Re: Consultation on an Application

Planning Application Ref: PL/26/0375

Address: 15 Coley Avenue, Reading, RG1 6LJ

Proposal: Proposed Single storey Rear and side extension and a Porch conversion

Google Maps – cars being parked in rear garden

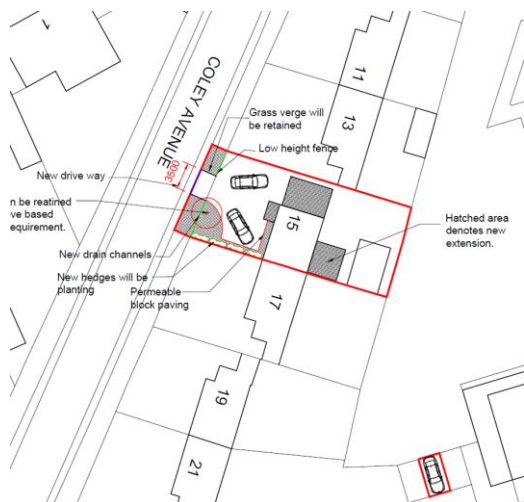
With reference to the LOCATION & BLOCK PLAN, March 2026, Drawing No. P1724-01, Rev A, I note the existing car parking arrangements in the rear garden are not plotted so the extent of the site's true existing parking arrangements isn't demonstrated. It is clear from the Google image above that cars are being parked in the rear garden of the property, along with an allocated space outside of the property's boundaries to the south-east.
